Transcivic
Engineering

Structural Report for the unauthorised work At 2/22 Warwick Street, Punchbowl

DATE:19/3/2022

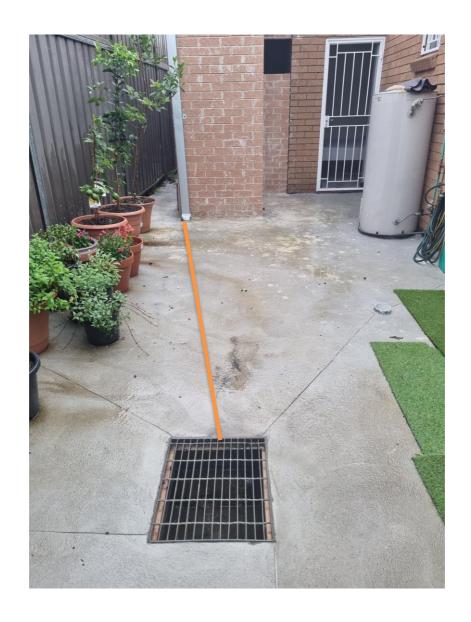
There is no bracing for the new brick work to the existing brick walls

Stormwater is connected to the existing

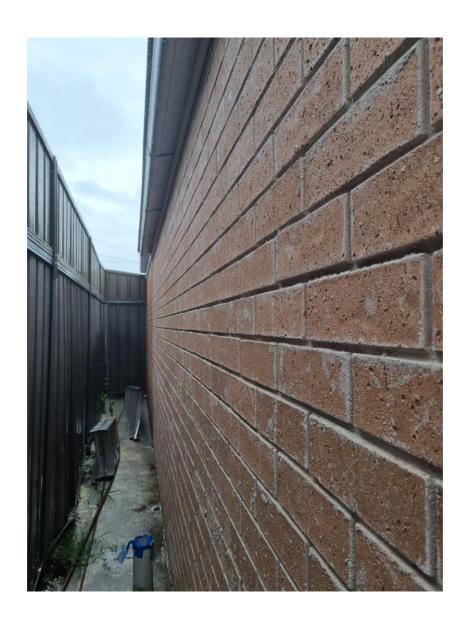
Single brick wall

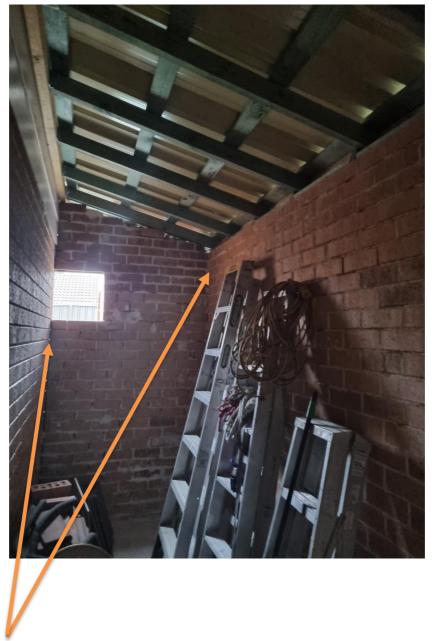
Either a brick veneer or double brick or single engaged piers wall to be applied

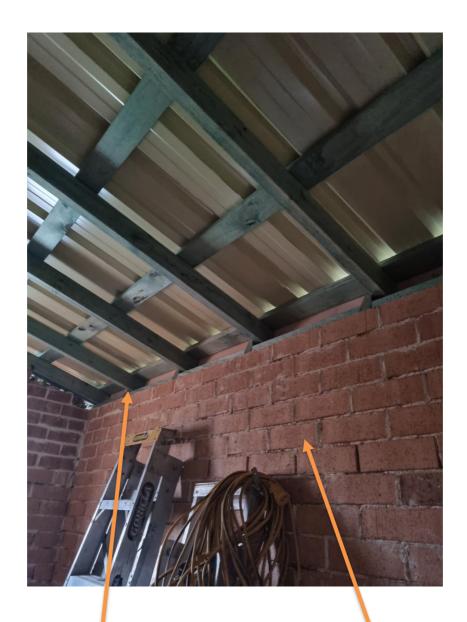
Engaged pier are missing to tie up the corner

Strap for up lift wind pressure on each rafter

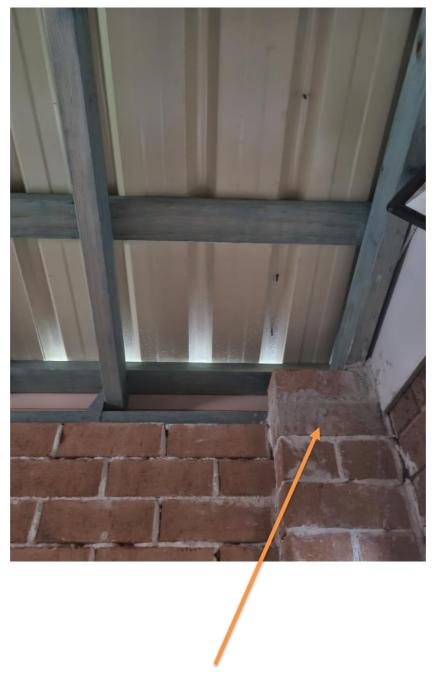
Engaged piers are missing

Missing Strap from brick pier to top plate as per AS1170
